129 DC - 367 Duncan Creek Rd., Lillington, NC 27546

PLAN 4 The Selma - LH 'CRAFTSMAN COUNTRY'

10-3-24 - Redlines- JJ

Slab Foundation 'Craftsman'

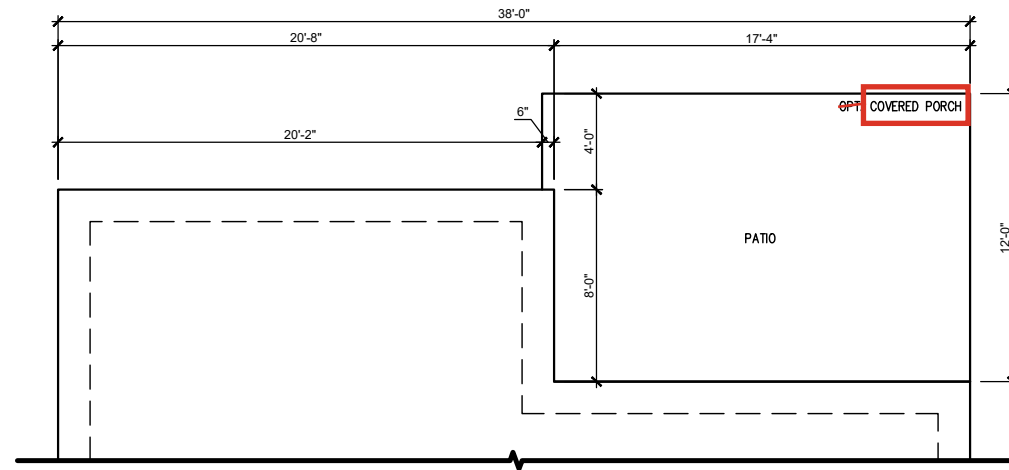
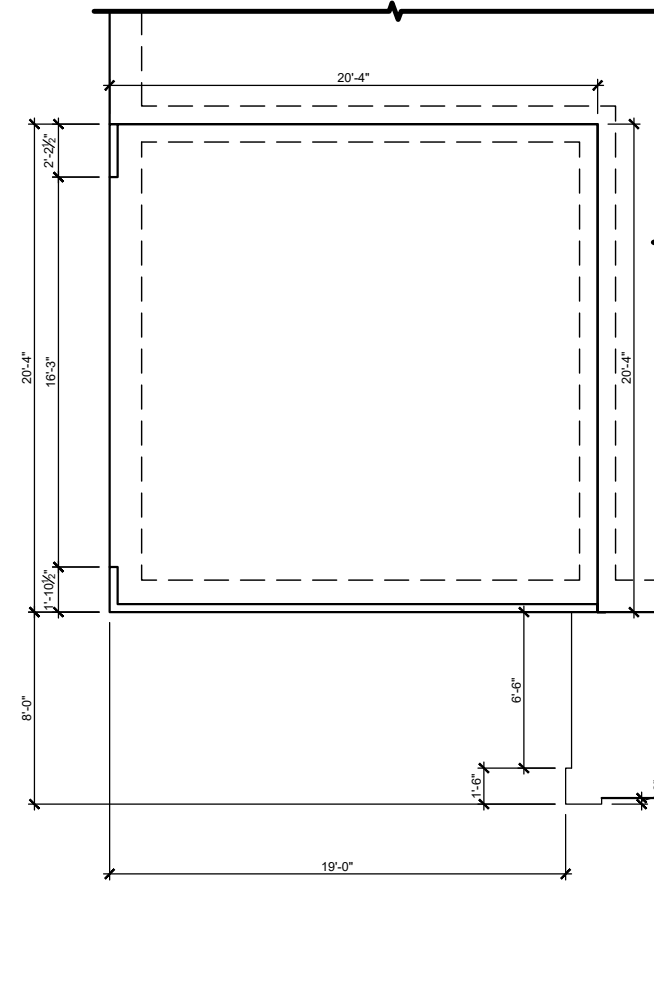
1.1.1d- pocket office foundation

1.1.1d side load garage

Shower ILO of tub

FIRST FLOOR PLAN 'CRAFTSMAN'
SCALE: 1/8"=1'-0" ON 11x17, 1/4"=1'-0" ON 22x34

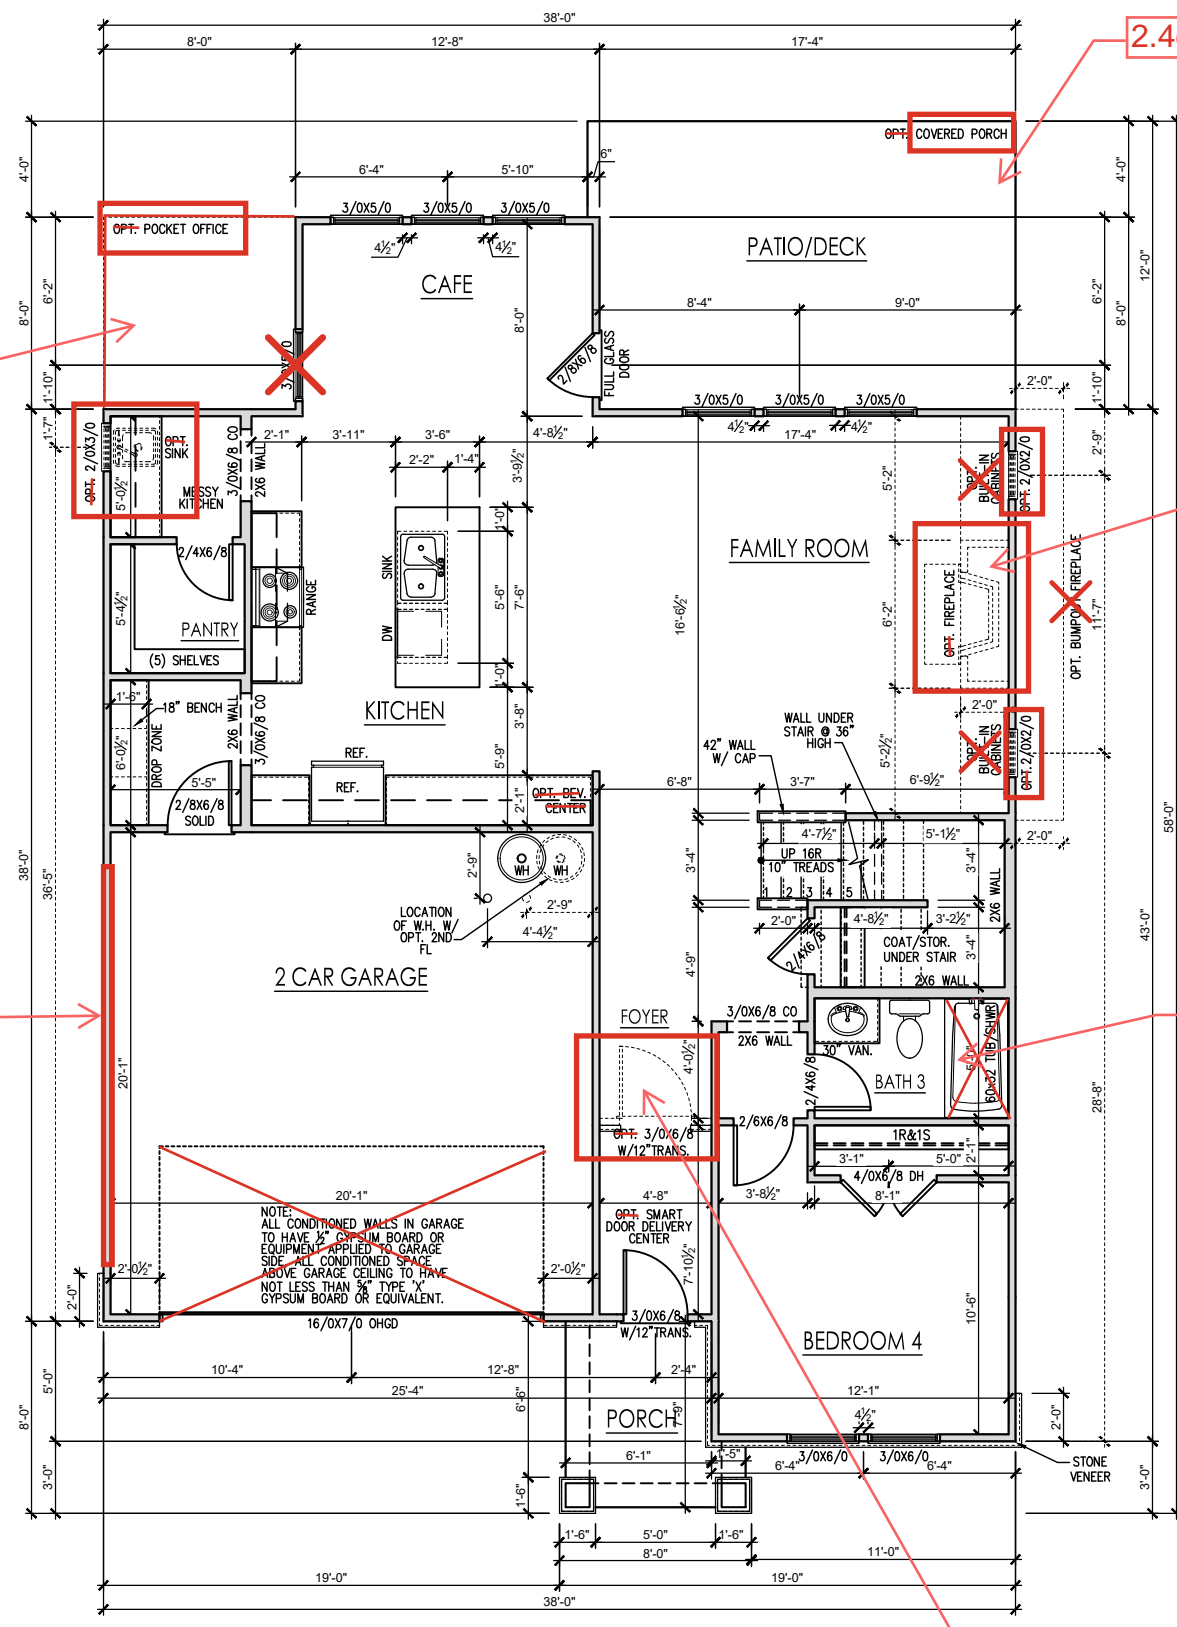
2.1.1d- pocket office

2.1.1d - side load garage

2.1.1d - Smart Door Delivery

'CRAFTSMAN' ELEVATION ROOF PLAN
 SCALE: 1/4" = 1'-0" ON 22x34, 1/8" = 1'-0" ON 11x17

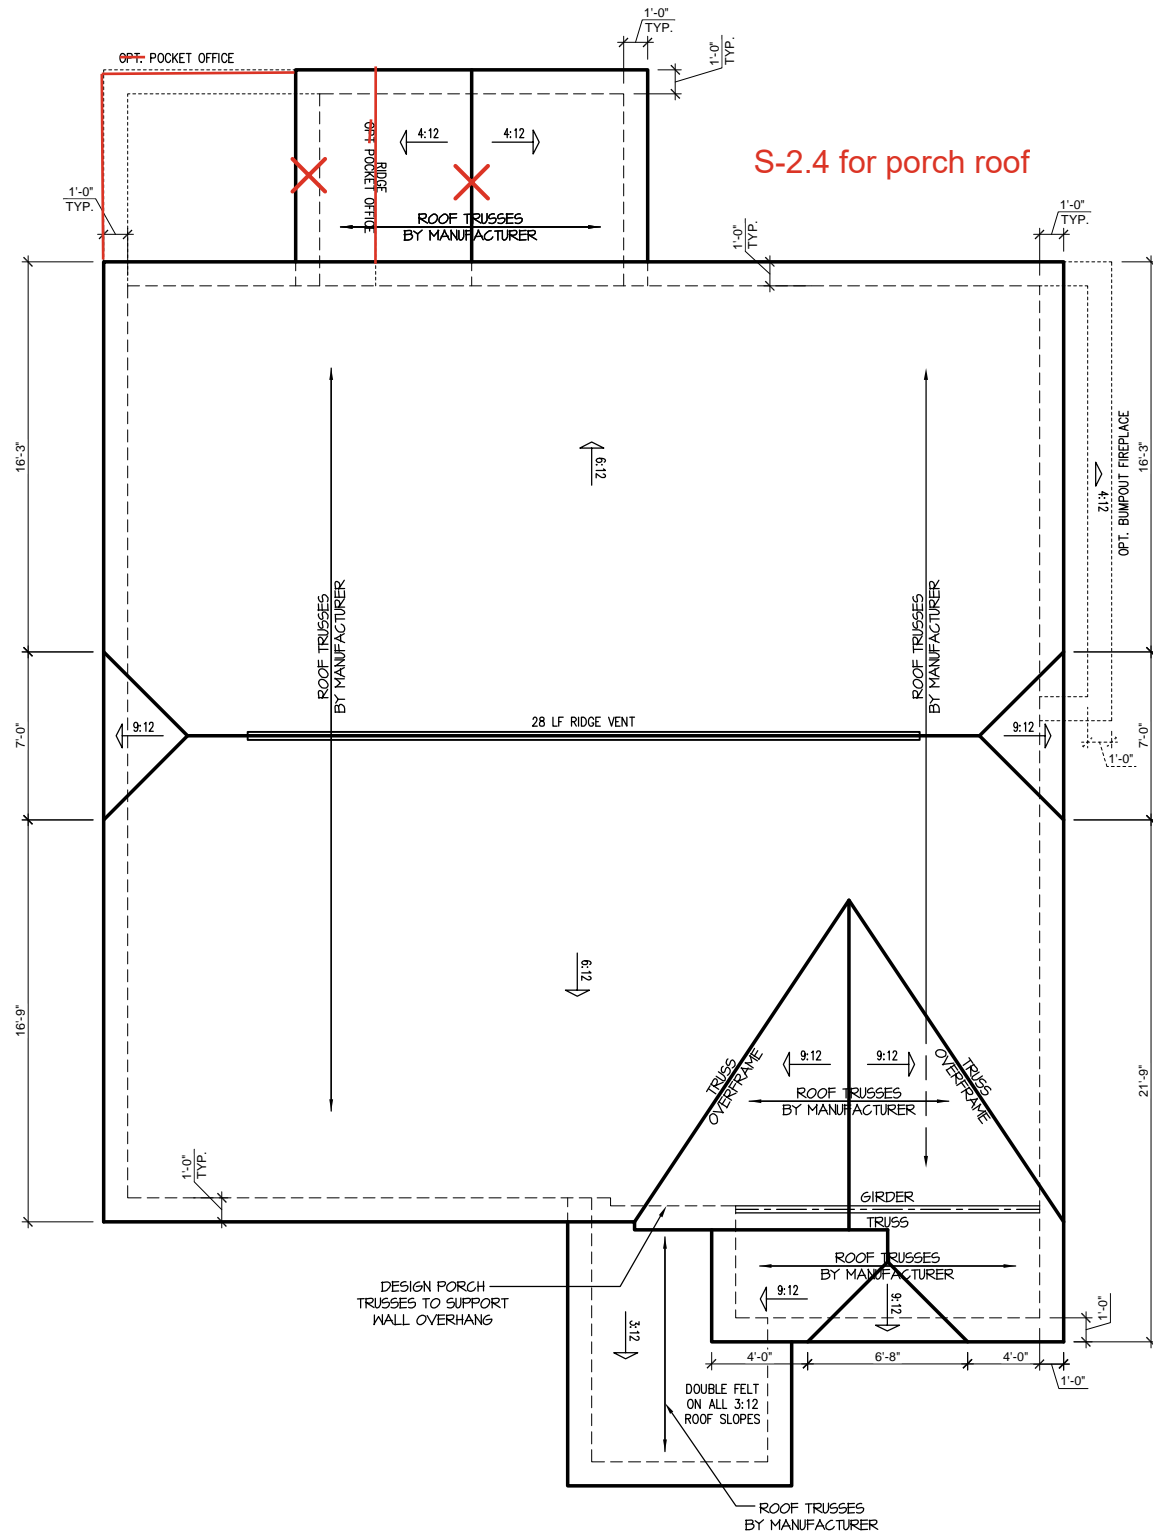
S-2.4 for porch roof
